BCA Assessment Report

Warehouse 4 | Aspect Industrial Estate
788/882 Mamre Rd
Kemps Creek NSW 2178

Mirvac

Revision 3

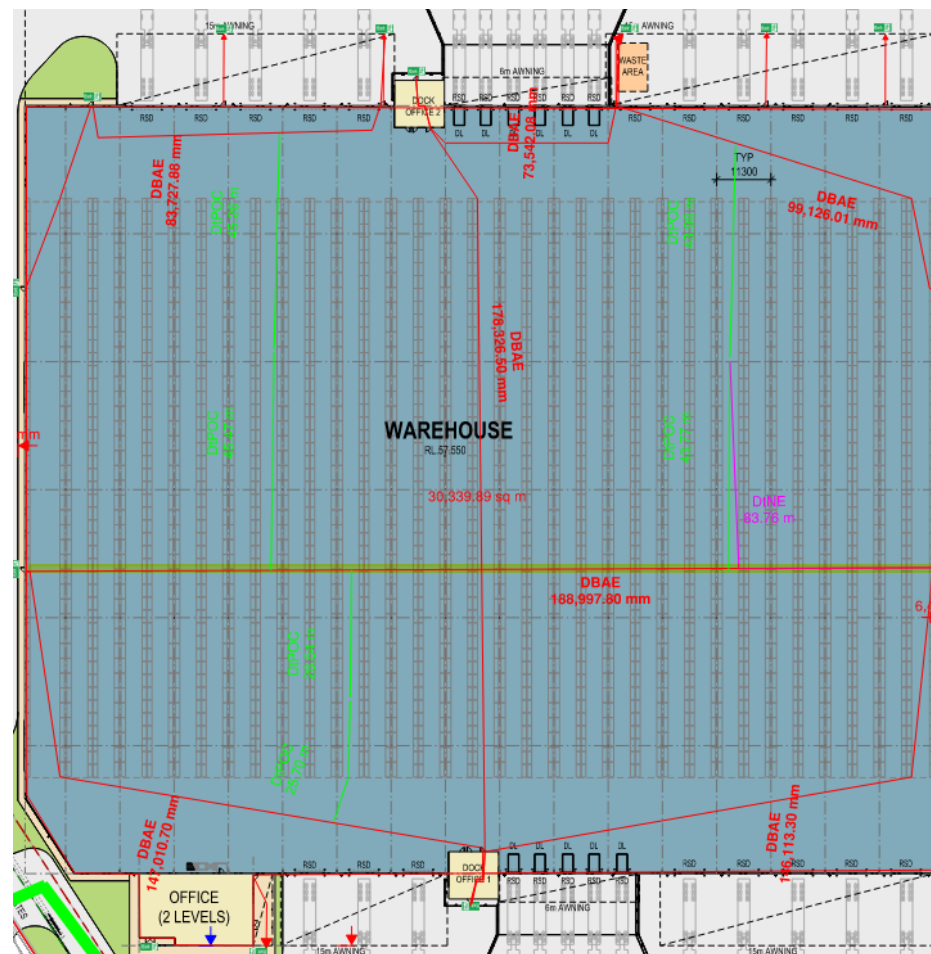
Comment: Exit travel distances to the point of choice are measured at 46 m and 84 m to the nearest exits. These distances exceed the prescriptive provisions and are therefore to be addressed under a fire-engineered performance solution. BM+G has allowed for an undercroft racking aisle between the vertical racks, which is to be reflected on the Construction Certificate architectural plans.

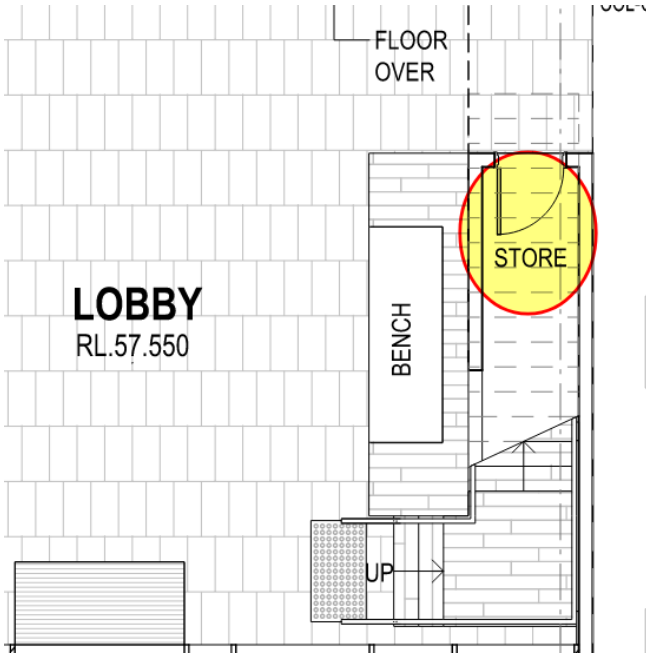
Comment: Where discharges from exits open to hard stand, bollards are to be installed.
